Item Name: Crosstube Aft

DART AEROSPACE LTD		Work Order:	98986
Description: Crosstube High Aft (205/212)		Part Number:	D212-664-201
Inspection Dwg: D212-664-241 Rev: D		Page 1 of 1

DART SERVICE INSTRUCTION

DRAWING NO. D212-664-241	TITLE CROSSTUBE ASSY (205/212 HI AFT)	REV. D	DART AEROSPACE LTD ENGINEERING ORDER		D.E.O. NO. D212-664-241-D-1	SHEET NO. SHEET 1 OF 2	SCALE NTS
DRAWN	CHECKED		MFG. APPR.		APPROVED	DE APPR.	
DATE 11.04.07	DATE 11.04.11		DATE 11.04.12		DATE 11/04/12	DATE 11.04.12

FIGURE 1: SUPPORT INSTALLATION

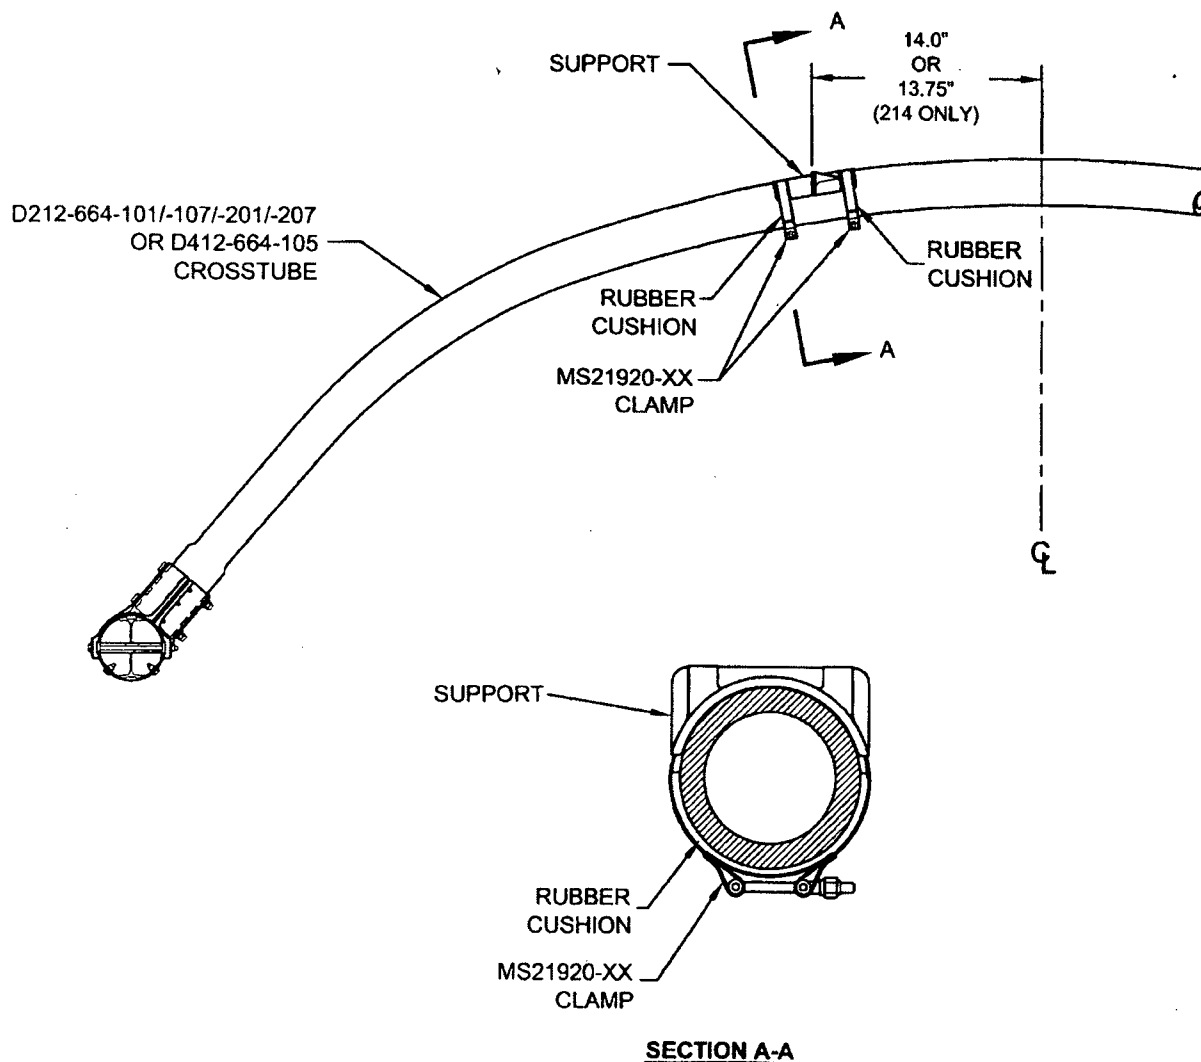
The supports on the following crosstubes are now installed using Proseal instead of Magnobond:

For the crosstubes listed above, section 32.4 of ICA-D212-664 is amended as follows. Use Figure 1 of this service instruction and Figures 32-2 to 32-9 of ICA-D212-664 for further reference. For crosstubes of an earlier change number, it is recommended that if the supports are removed, the supports should be reinstalled using the procedure listed below.

- 32.4.5 Apply a 0.04" to 0.07" thick layer of Proseal 890 Class B or AMS-S-8802 Class B sealant underneath applicable support and install support as shown in Figure 1 of this service instruction.

- 32.4.6 Install the clamps opposite to crosstube support as shown in section A-A of Figure 1. Install rubber cushions underneath each clamp around the bottom circumference of the crosstube up to the crosstube centerline. Torque clamps 80-100 in-lb (9.0-11.3 Nm). It is acceptable to use smaller or larger sized MS21920-XX clamps than those listed in ICA-D212-664, ensure that after torquing the clamps per this instruction, the nuts are in safety but not bottomed out

**D212-664-241/-241B
ASSEMBLY DETAIL**

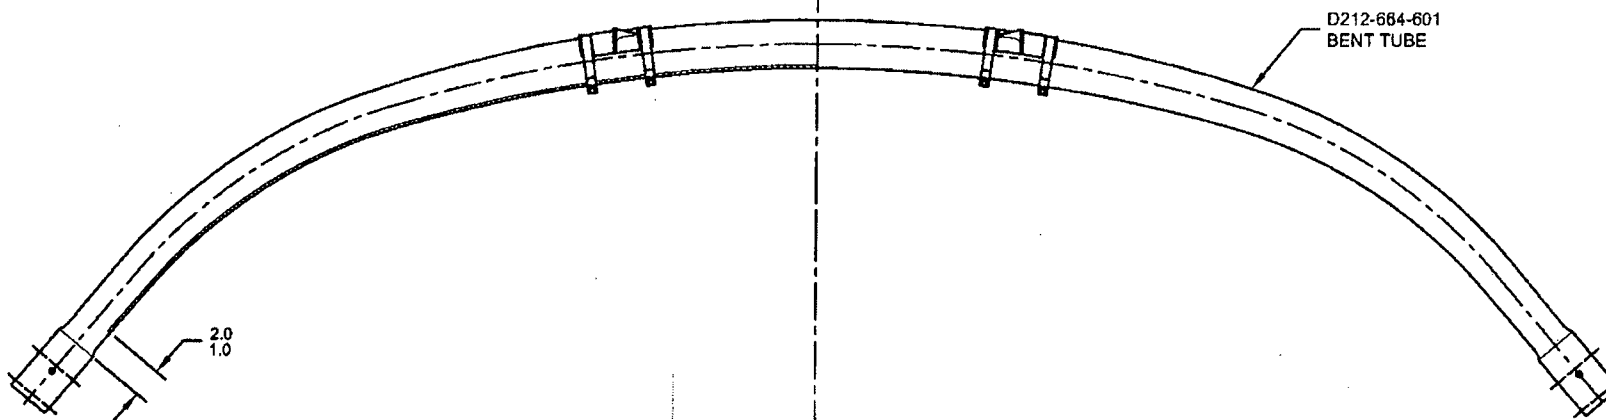
ADD AN INSPECTION WINDOW TO UNDERSIDE OF CROSSTUBE.

NOTES 2 OF SHEET 1 IS AMENDED AS FOLLOWS:

IS:

WAS:

MASK AREA PRIOR TO PAINTING,
REMOVE MASKING AFTER PAINT
AND APPLY CLEAR COAT

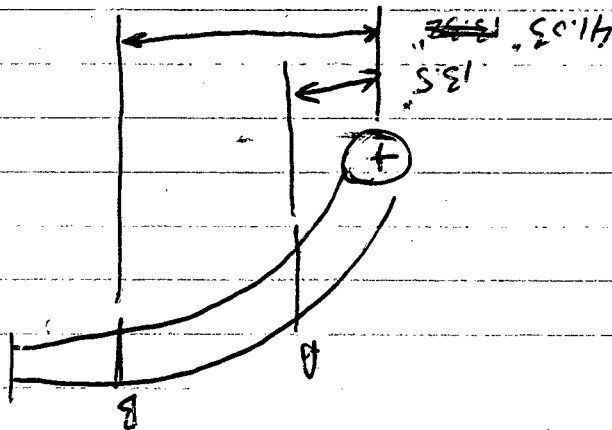
REPLACE MAGNOBOND WITH PROSEAL.

NOTE 12 & 15, SHEET 1 IS AMENDED AS FOLLOWS:

IS:

WAS:

- 12) TO INSTALL D2940-1 SUPPORT: ABRABE MATING SURFACE OF SUPPORT AND CROSSTUBE WITH 180-GRIT SANDPAPER AND REMOVE RESIDUE WITH MEK (OR EQUIVALENT). APPLY A 0.04" TO 0.07" THICK LAYER OF PROSEAL 890 CLASS B-2 (OR AMS-S-8802 CLASS B-2) SEALANT TO MATING SURFACE OF SUPPORT.
- 15) TORQUE CLAMPS 80 TO 100 IN-LB. ENSURE AT LEAST 1.5 THREADS SHOWING IN SAFETY AND THAT NUT HAS NOT BOTTOMED-OUT AFTER TORQUING. **PRIOR TO PACKAGING, RE-CHECK TORQUE ON CLAMPS AFTER PROSEAL 890 SEALANT HAS CURED FOR 72 HOURS.**
